PRODUCT CHANGE NOTIFICATION (PCN)

AMJE0909-0700-BKB-24
MODULAR CABLE

CHANGE NOTIFICATION: PCN 20220509_AMJE0909-0700-BKB-24

DESCRIPTION OF CHANGES:
CHANGE OF DATA SHEET
CHANGE OF DATA SHEET
New Draw.-No. ASS_7945_CArev02

Apprearance

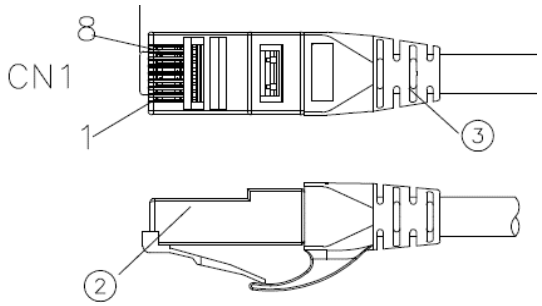
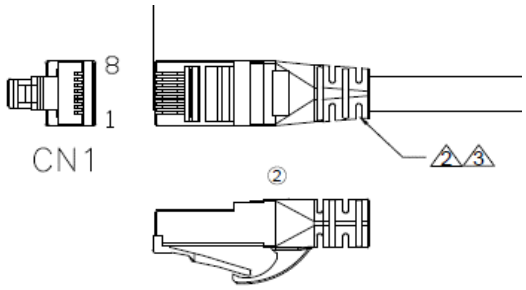
③	Molding	PVC 45P Color: see order code	NA	KG
②	CONNECTOR	RJ45 8P8C two fork Short type 3u" gold plated	2	PCS
①	CABLE	CAT6 UTP (24AWG*1PR)*4+PVC OD=5.8±0.3MM Color: see order code	NA	MM
NO:	NAME	DESCRIPTION	Q'TY	UNIT

3	Molding	PVC 65P Color: see order code ②	NA	KG
2	CONNECTOR	RJ45 8P8C PLUG 3u" gold plated ②	2	PCS
1	CABLE	CAT6 U/UTP (24AWG*1PR)*4+Cross+PVC Jacket OD=5.8± 0.3MM Color: see order code ②	NA	MM
NO:	NAME	DESCRIPTION	Q'TY	UNIT

Drawing-No.
ASS 7945 CA

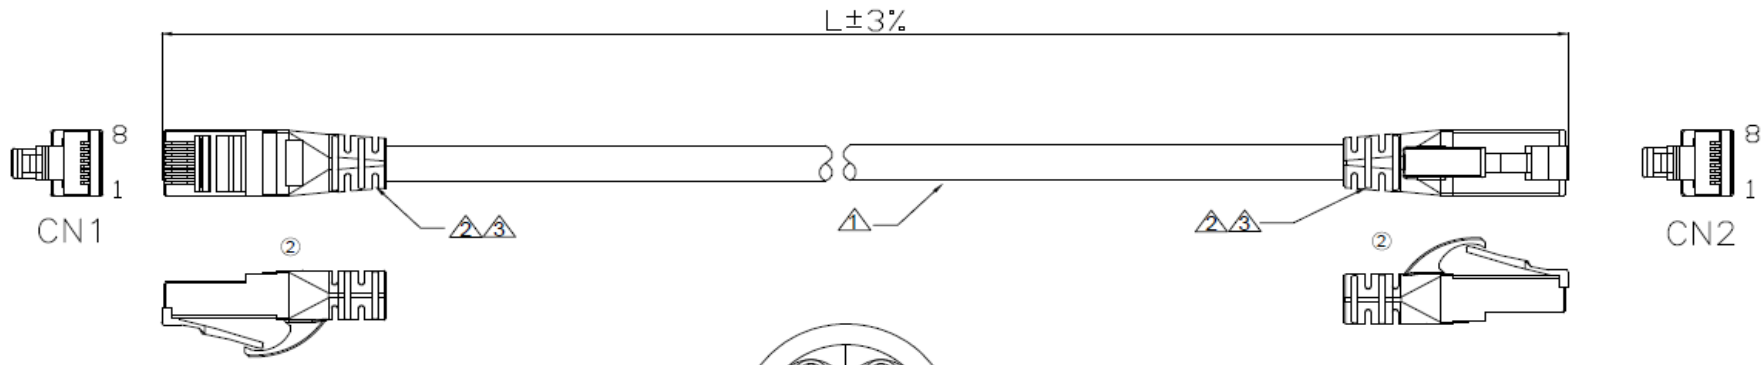
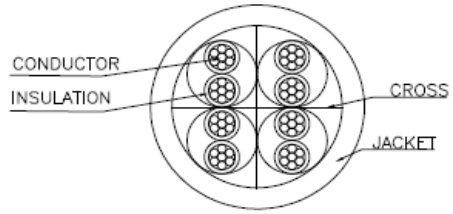
Id.	Modification	Date	Name
②	Change the plant	09.05.2022	Luca
①	Update the WSW order code	02.06.2017	Amy
⓪	Drawn	30.03.2017	Amy

NO:	NAME	DESCRIPTION	Q'TY	UNIT
3	Molding	PVC 65P Color: see order code ②	NA	KG
2	CONNECTOR	RJ45 8P8C PLUG 3u" gold plated ②	2	PCS
1	CABLE	CAT6 U/UTP (24AWG*1PR)*4+Cross+PVC Jacket OD=5.8± 0.3MM Color: see order code ②	NA	MM
